ADDENDUM NO. 1

Notice to All Persons and Firms Proposing
to Submit a Bid or Furnish Materials for
Lucas-Hunt Road (South) ARS Infrastructure
St. Louis County Project No. AR-1586
Federal Project No. STP-9901(630)

CONSTRUCTION PLANS FOR LUCAS AND HUNT ROAD SOUTH ARS INFRASTRUCTURE ST. LOUIS COUNTY PROJECT NO. AR-1586 FEDERAL PROJECT NO. STP-9901(630)

TITLE SHEET

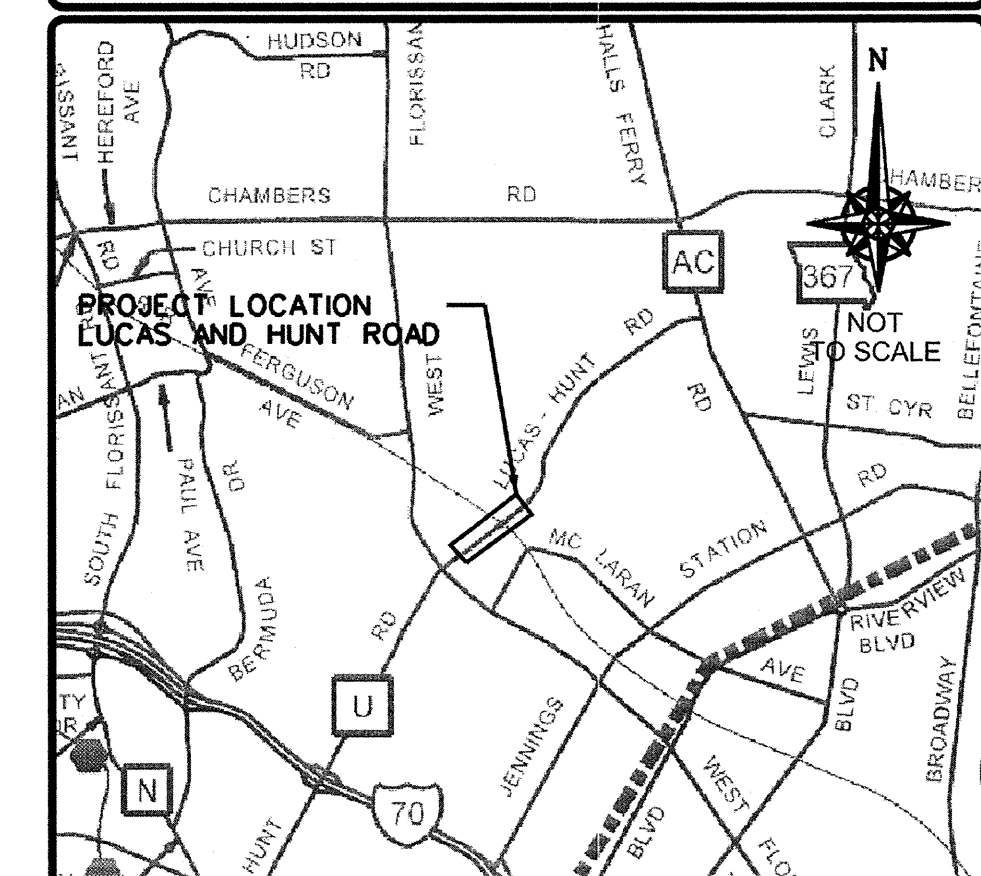
Revised Plan Sheet No. 1 of 37 "Title Sheet", Index of Sheets, deleted Plan Sheets 26 and 27 of 37.

REV	DATE	BY	APP	DESCRIPTION
1	7-2-18	CJE	JWD	Remove Sheet 26 and Sheet 27
